Service Information

Category F	Repair Guidance	Ref. No. R009/13	Page 1 of 2
Coverage <input type="checkbox"/> Distributor only <input checked="" type="checkbox"/> Please inform your dealers		Date Issued January 24, 2013	
Please convey this information to your <input type="checkbox"/> Director <input checked="" type="checkbox"/> General Manager <input checked="" type="checkbox"/> Warranty Dept. <input checked="" type="checkbox"/> Parts Dept. <input checked="" type="checkbox"/> Training Dept. <input checked="" type="checkbox"/> Field Rep.		Date Revised	
Applicable Model Mazda6 (GJ) with SKYACTIV-D 2.2 with Auto Cruise		Applicable Countries or Specifications ADR, Europe

Subject: Wrong indication i-ELOOP gauge when driving with auto cruise ON

aatjn00001746

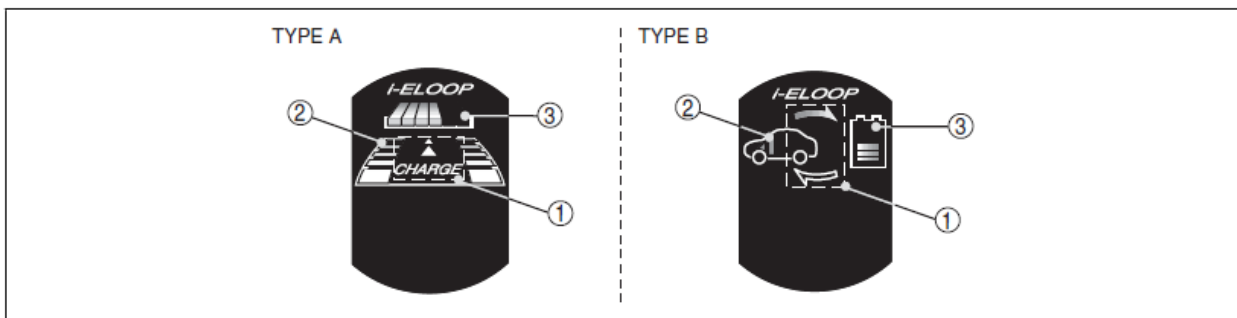
Some customers may complain that i-ELOOP gauge on the combination meter indicates “i-ELOOP in operation” as described below despite the vehicle is driven at a constant speed by the use of cruise control system.

1. Regenerative deceleration power generation condition gauge indicates that i-ELOOP is generating electricity using deceleration energy by the display of “CHARGE” for TYPE A or “Arrows” for TYPE B.
2. Regenerative deceleration power generation amount gauge is fixed at 3 scales.
3. Capacitor (i-ELOOP) accumulation amount gauge does not increase.

The control logic of PCM has been changed.

1. Reprogram the PCM with M-MDS using IDS 82.04 or later software, or IDS 83.01 or later software.
